CITY OF CODY  
PLANNING, ZONING AND ADJUSTMENT BOARD  
TUESDAY, APRIL 12, 2016  
CITY HALL COUNCIL CHAMBERS @ 12:00 NOON

**CITY OF CODY  
PLANNING, ZONING AND ADJUSTMENT BOARD  
STAFF REPORT**

<b>MEETING DATE:</b>	APRIL 12, 2016	<b>TYPE OF ACTION NEEDED</b>	
<b>AGENDA ITEM:</b>		P&Z BOARD APPROVAL:	X
<b>SUBJECT:</b>	SITE PLAN REVIEW: CROSSFIT CODY GYM (SILVER GATE ENTERPRISES) FILE: SPR 2016-08	RECOMMENDATION TO COUNCIL:	
<b>PREPARED BY:</b>	TODD STOWELL, CITY PLANNER	DISCUSSION ONLY:

1 OVERALL SITE PLAN  
AS1.1 SCALE: N.T.S. NORTH

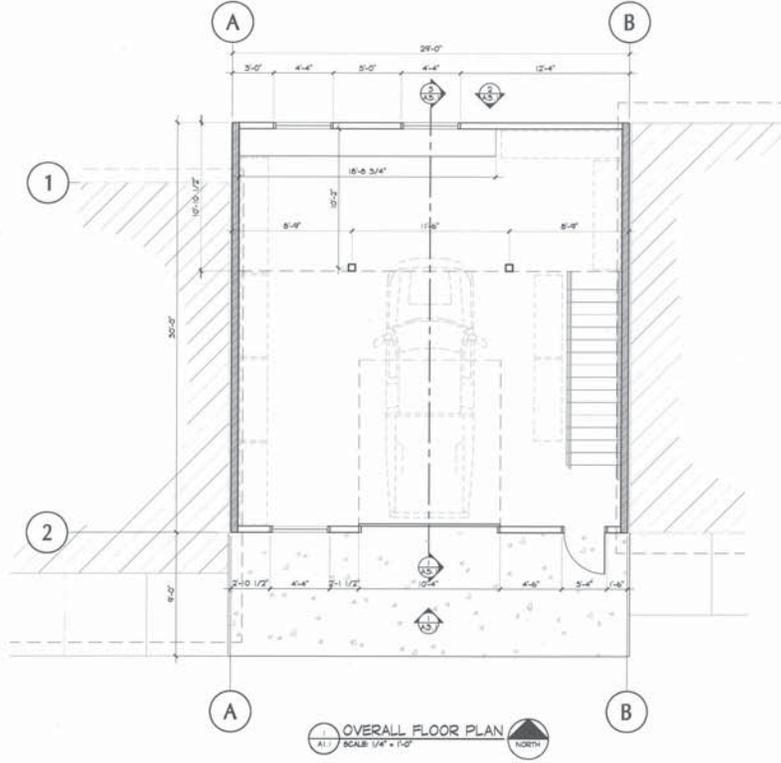
The application did not include a detailed site plan. It appears that the building will be about one foot from the north property line, which may trigger some fire code standards that would result in elimination of the windows shown on the plans. Other than that change, the building will appear architecturally as shown on the plans. There is no zoning setback required.

There is what appears to be a sewer cleanout about one foot from the north property line, near the middle of the proposed building. It is not known if the line runs east-west

or north-south. In any case, it is not a city main, but will still need to be accommodated in the building design and construction.

Approve the storage building as submitted. The utility and construction issues will be addressed with the building permit.

PLANTING PLAN  
SHEET  
**L300**

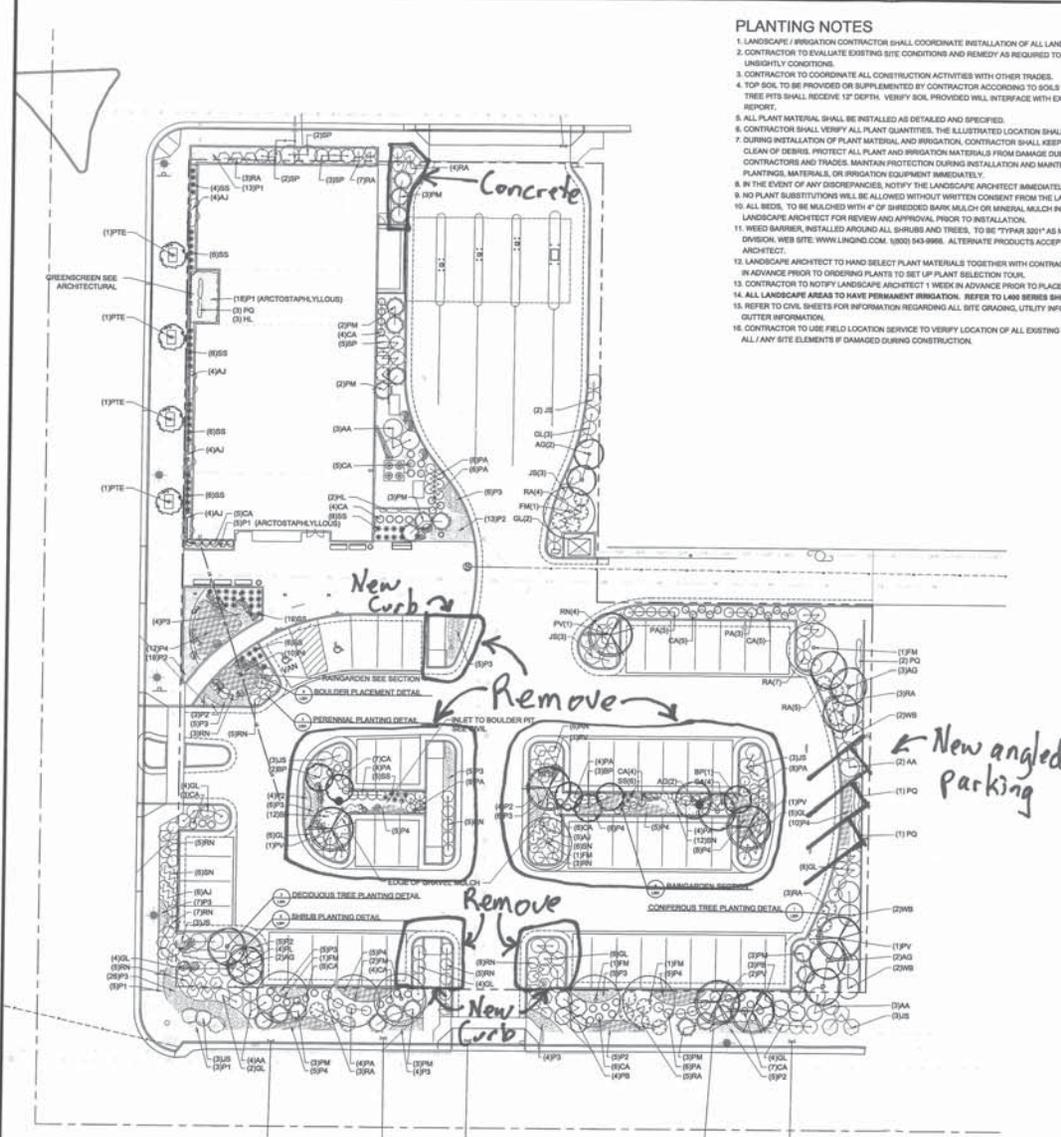
The application does not include detailed plans for the work. There are specific minimum dimensional requirements for the parking spaces and aisles, which are planned to be met, but which are not drawn out. Also, the storm water inlets and cleanouts will need to be modified to have traffic rated lids that match the grade of the asphalt. To maintain clean edges and gradual slopes across the parking lot, the asphalt will be cut back beyond the limits of the landscape islands.

As the work will greatly disrupt the availability of parking, there needs to be a plan for how to accommodate the parking demand. It may be necessary to split the work into phases, so that a significant portion of the parking lot is still available during business hours.

1. The owner and their contractor must work closely with City staff to make sure the improvements meet City standards and standard engineering practices. Drawings and specification sheets may be required.
2. A plan for accommodating parking demand during construction must be presented and approved.

**SITE PLAN**

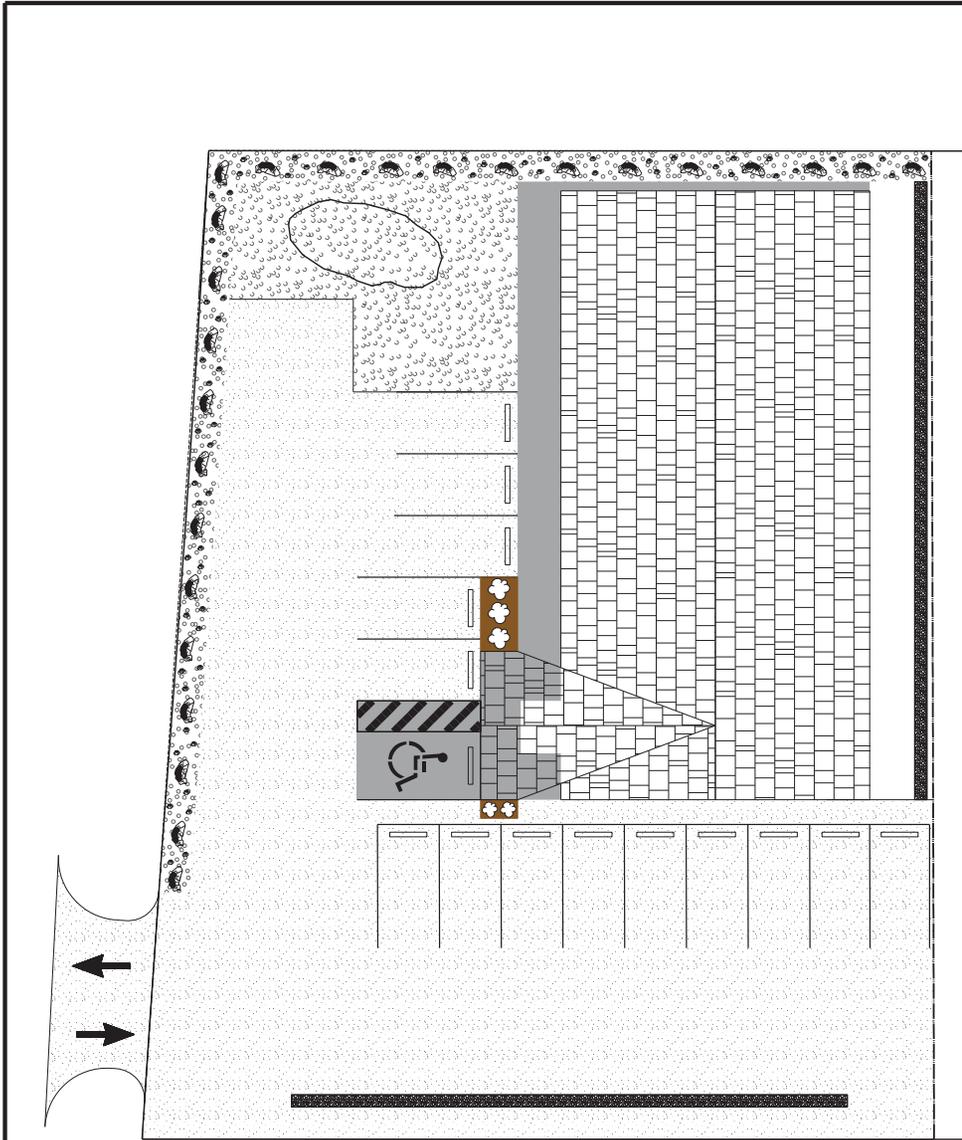
The site plan correctly shows sidewalk being installed along the Cougar Avenue curb and gutter that exists.

The parking plan is in compliance with the City off-street parking regulations for parking stall and aisle dimensions, grading, location, ADA spaces, and configuration. However, it is lacking a paved approach onto Blackburn Street. In accordance with the City

The locations and sizes of the existing and proposed utility services are shown on Sheet 1. The plans lack some details. Specifically, the water service line must be a minimum of 200 psi CTS, and the sewer service lines must be PVC type SDR35 or better. The plans also do not show how the primary power will tie into the existing system. For now the Board can simply specify that the utility materials and installations must meet City specifications. However, the as-constructed set of plans will need to be complete with the utility service information.

It is also noted that when staff last spoke with the applicant, the sewer services were going to be 6", so that maximum depth of sewer for the undeveloped portion of the property is available. The current plans show 4" services, which require a steeper slope and therefore may not be able to serve all of the future development on the east side of the property. Please verify size and slope.

1. Provide an updated site plan with the building permit which identifies the exact utility service connection methods, pipe materials, pipe/conduit sizes, and depth of

- bury. Provide an as-constructed plan set after construction is inspected and complete.
2. Provide an asphalt or concrete approach to Blackburn Street that extends the width of the approach and runs at least 25 feet. The asphalt must be installed on a suitable base. Provide details with the plans submitted with the building permit.

ELEVATION VIEWS

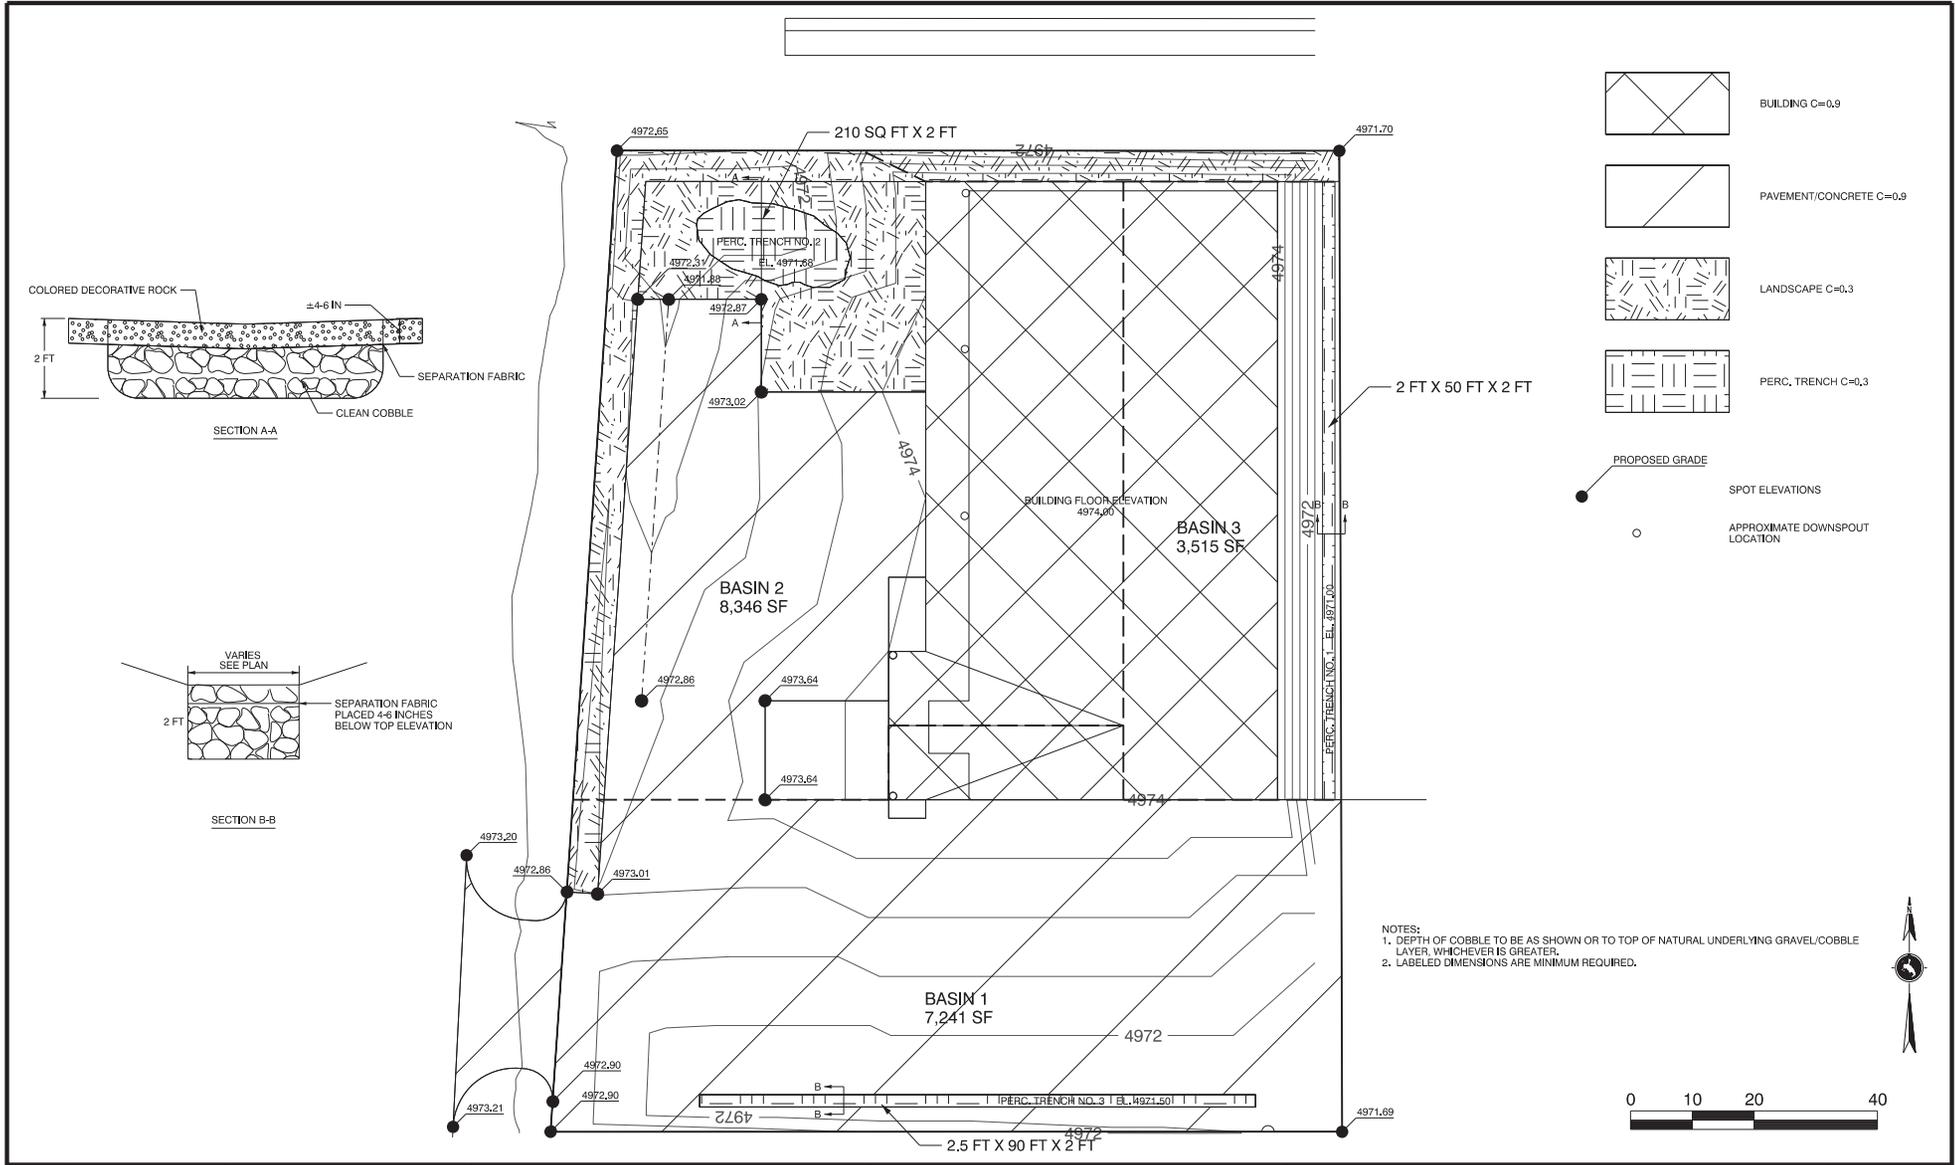
In the past the Board has been lenient on architecture when the landscaping plan was elaborate, and vice versa. However, in this case the landscaping is minimal, and the parking lot will be gravel, which combination lacks the finished look of the surrounding quality properties.

12. The project must otherwise comply with the site plan and applicable building, fire, and electrical codes.
  13. Any other landscaping or architectural requirements. (e.g. additional architectural enhancements; landscape the 10' strip east of the building—to future property line.)

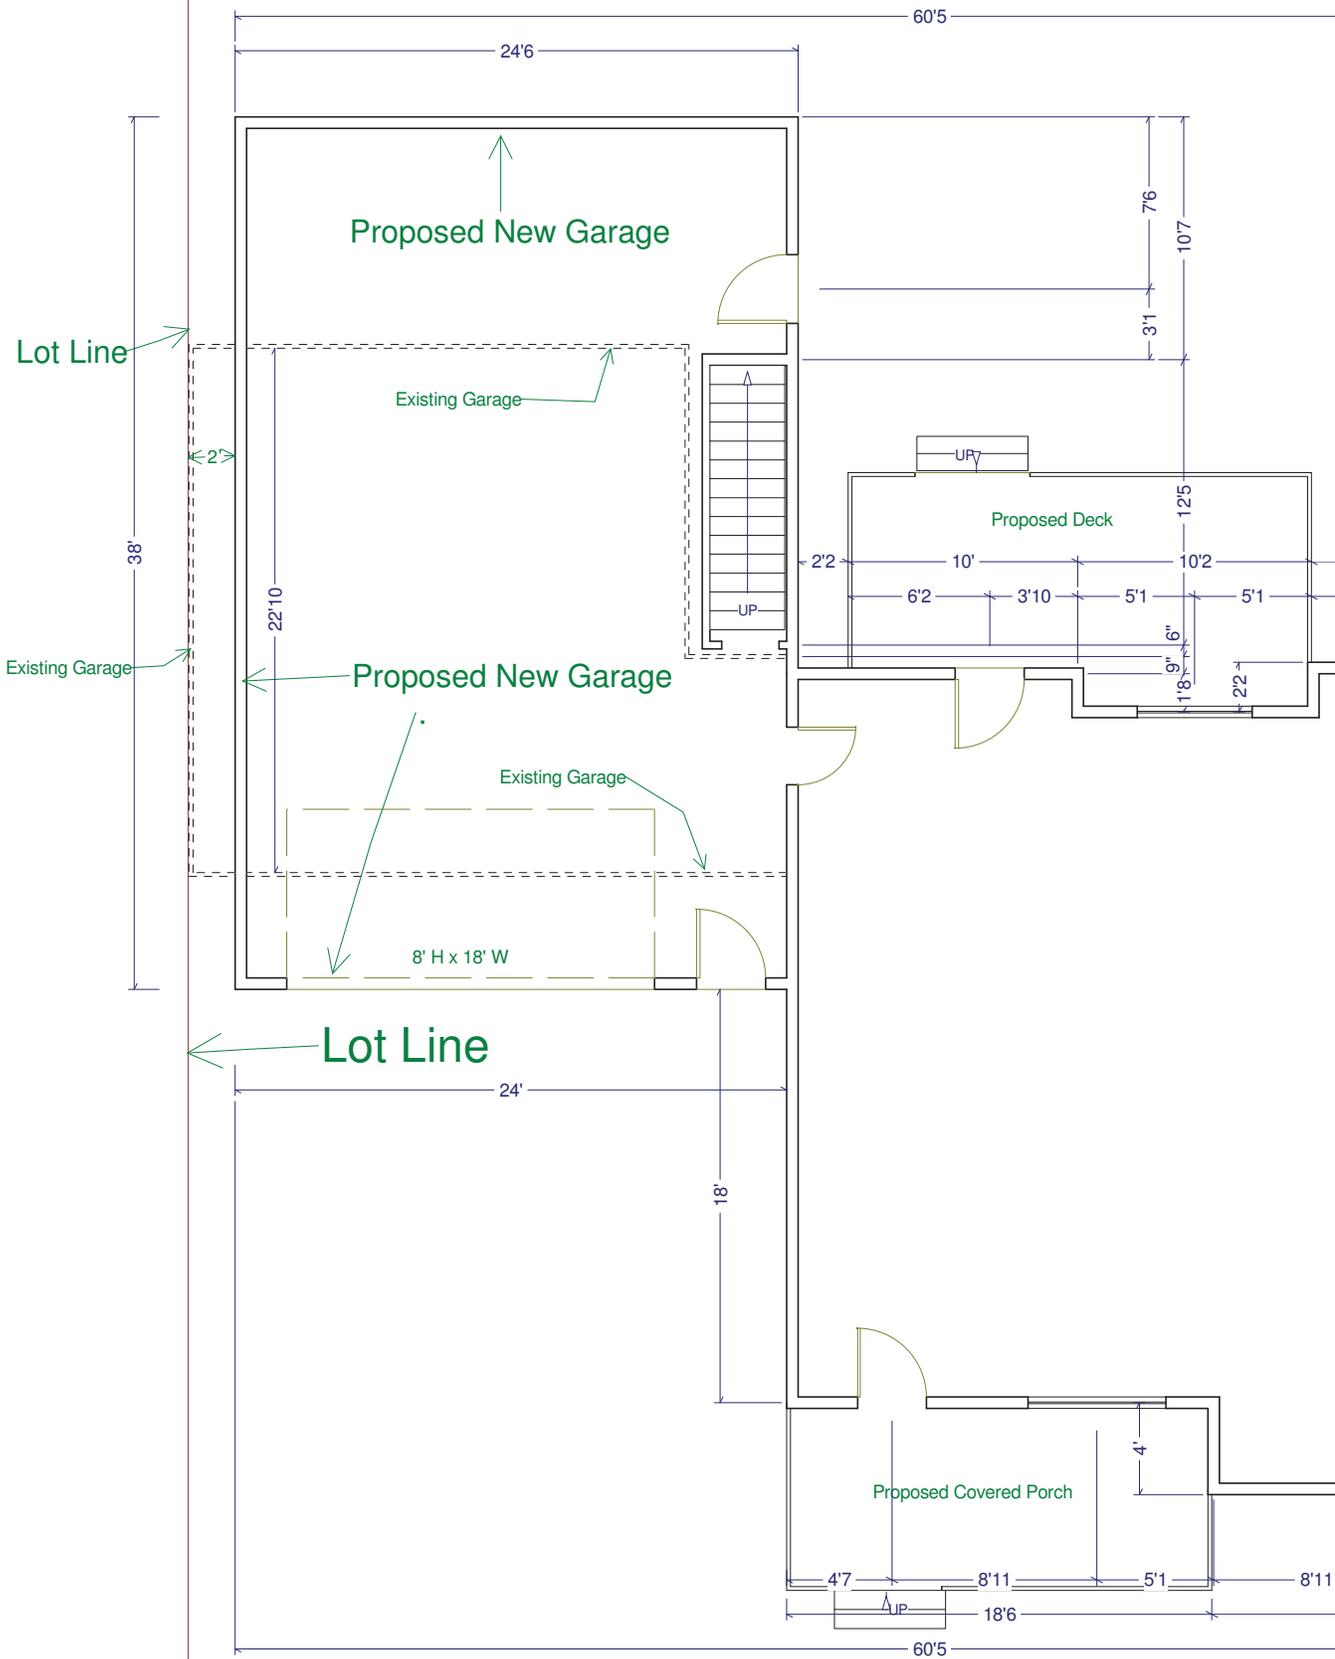
Staff Comment: The project would result in the building being two feet from the property line, while the existing garage is immediately next to the property line. However, the length of the encroachment into the setback would be extended from the current 24 feet to 38 feet—the depth of the addition.

The change from single story to two story is visually significant, yet it is noted that due to building/fire code restrictions, there will be no windows or openings in the wall nearest the property line, so privacy for the neighbor is actually better than if the addition met the 5-foot setback and had windows in that wall. Also, the existing garage does not meet fire code, but the new construction will.

It is noted that the site plan shows other construction on the property—a front porch and rear deck. The review in this staff report is limited to the setback from the west property line only. Additional research and analysis of a sewer main running north through the property will be needed before a building permit can be issued for any of the improvements.
